SCHOMP HYUNDAI SITE PLAN MINOR AMENDMENT

ACTION CIVIL ENGINEERING 9777 PYRAMID CT., SUITE 150 ENGLEWOOD, CO 80112 720.826.3965 tdenning@actioncivleng.com		JOB NO. 2203	
		SCALE ----	
		DATE 9/15/2022	
SHEETS 7		SHEET 1	
SCHOMP HYUNDA SITE PLAN MINOR AMEINTMENT 100 NORTH HAVANA STREET, AURORA, COLORADO 80010			
COVER SHEET			
DSG		TWD	
CHK		TWD	
#		DATE	
1		3/9/22	
SUBMITTED TO AURORA			
2		6/24/22	
SUBMITTED TO AURORA			
3		9/15/22	
SUBMITTED TO AURORA			
DRN			
TWD			
REVISION DESCRIPTION

SITE PLAN

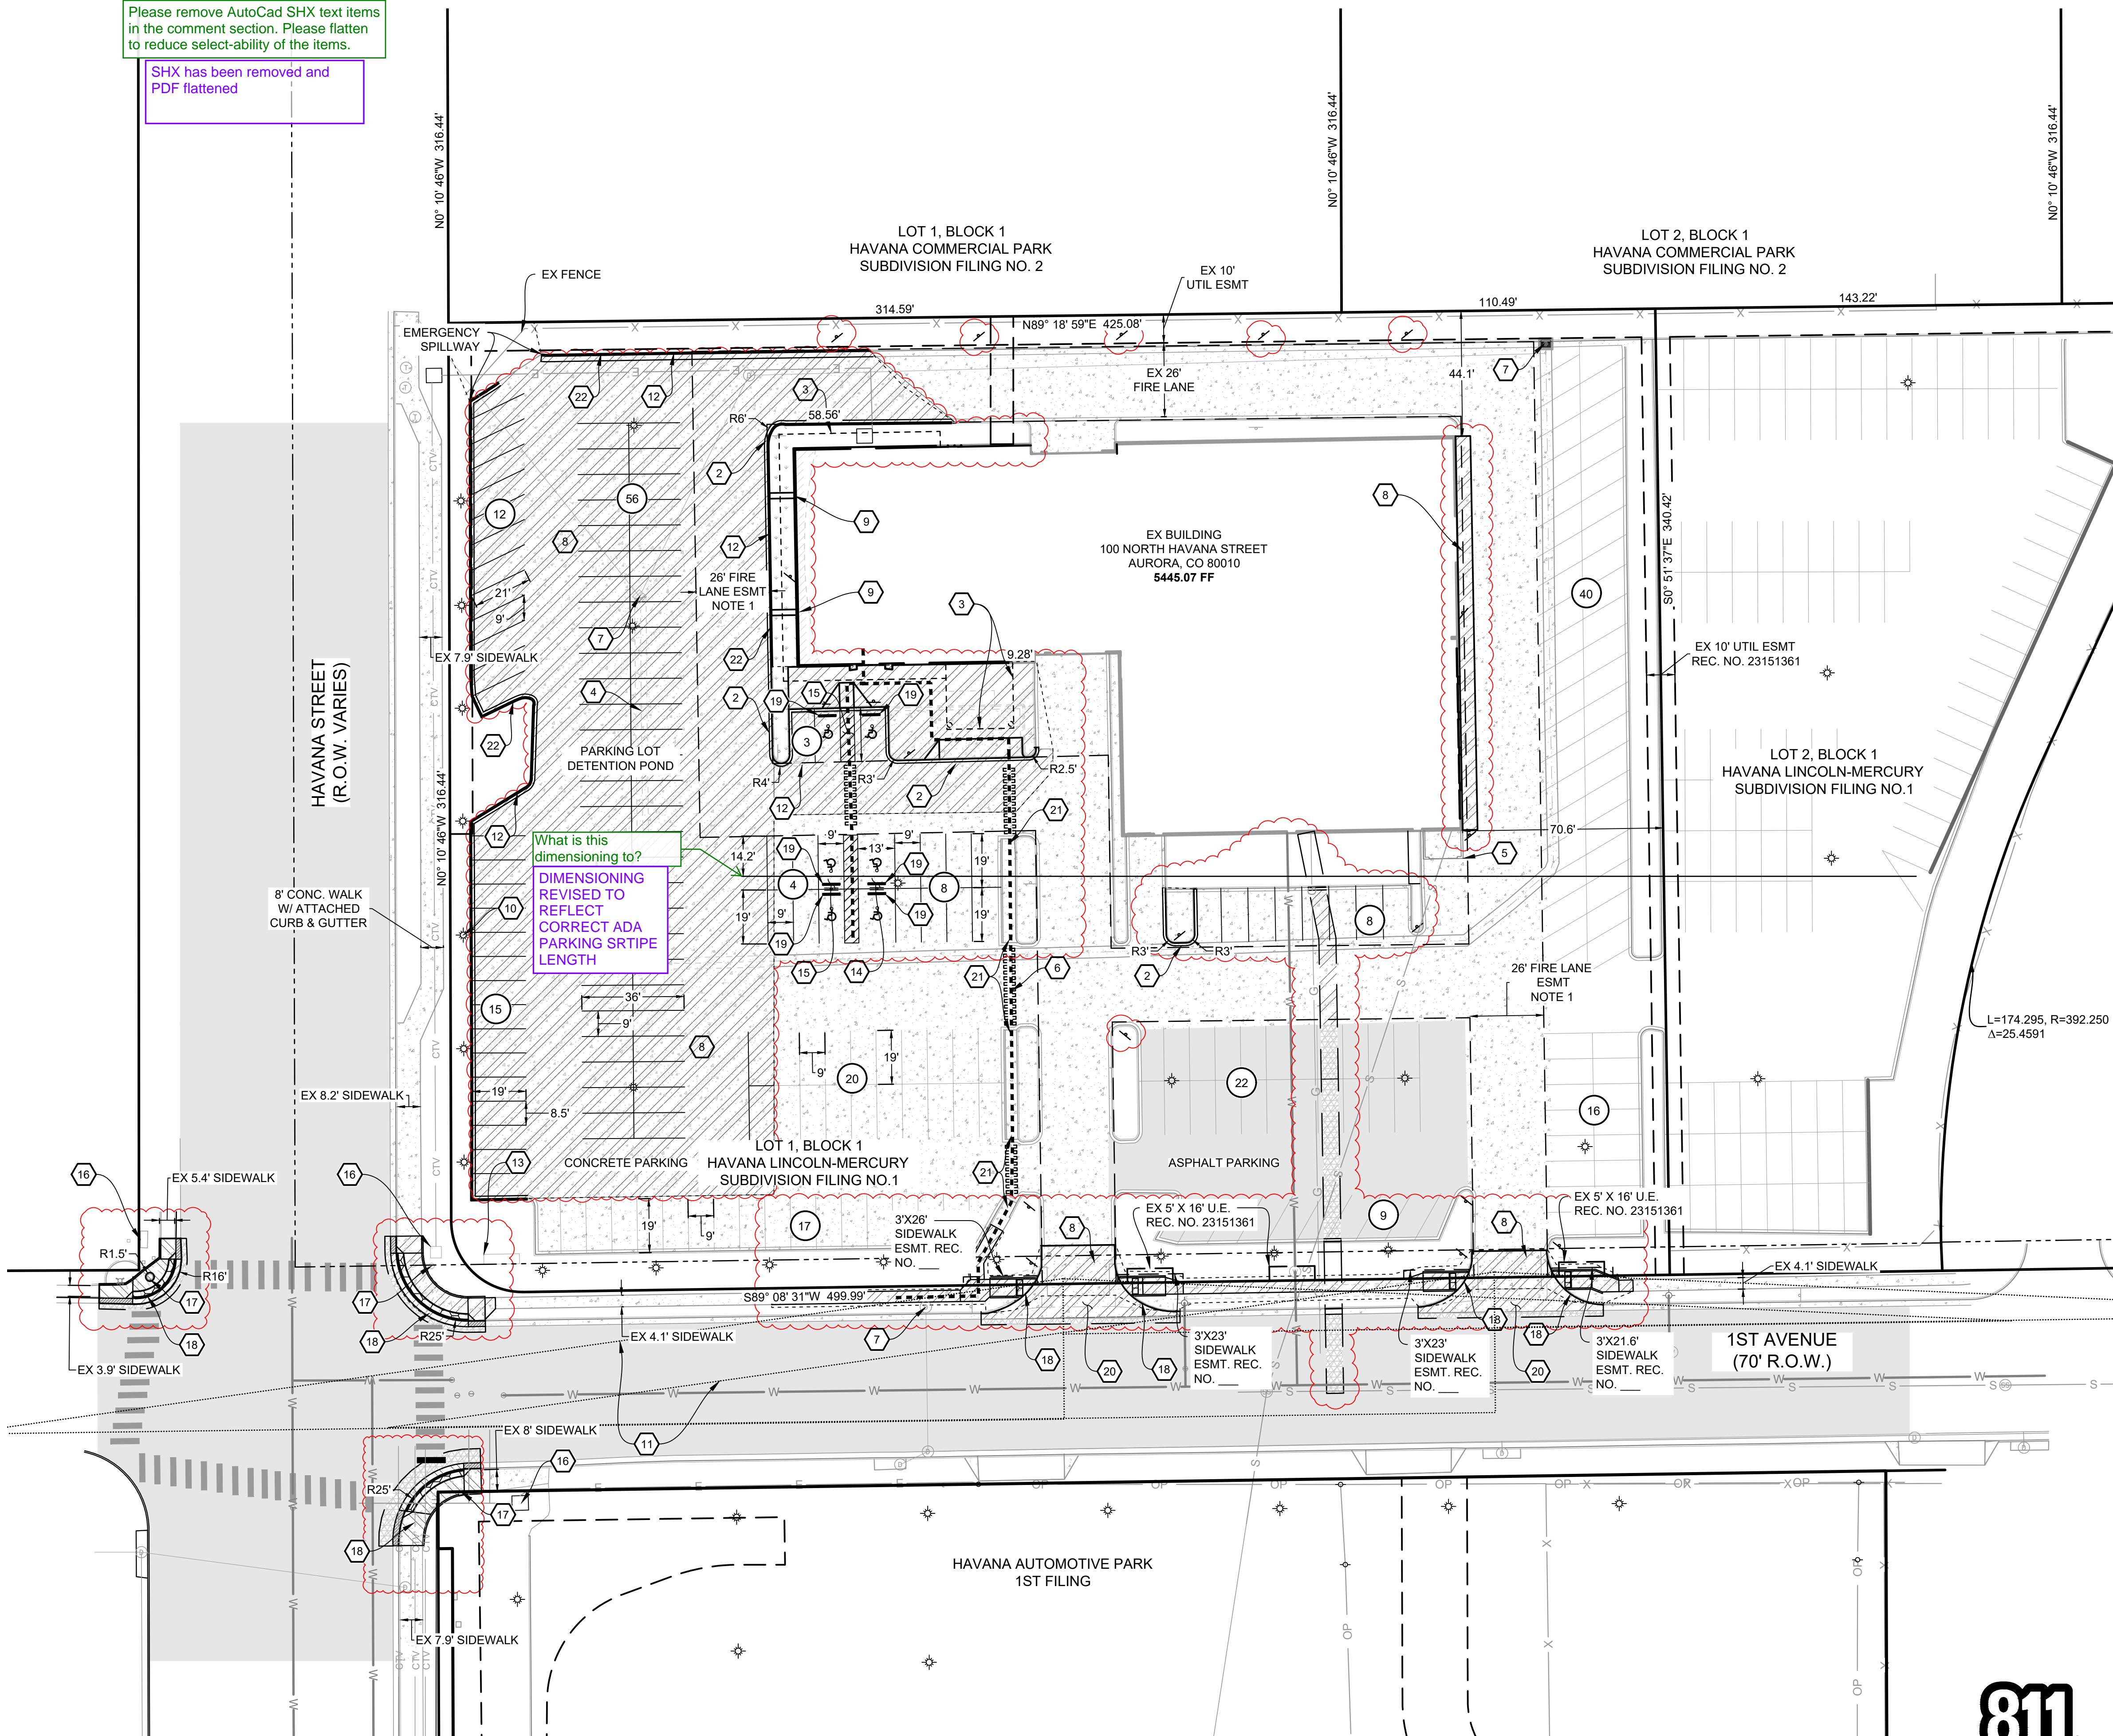
Please remove AutoCad SHX text items in the comment section. Please flatten to reduce select-ability of the items.

SHX has been removed and PDF flattened
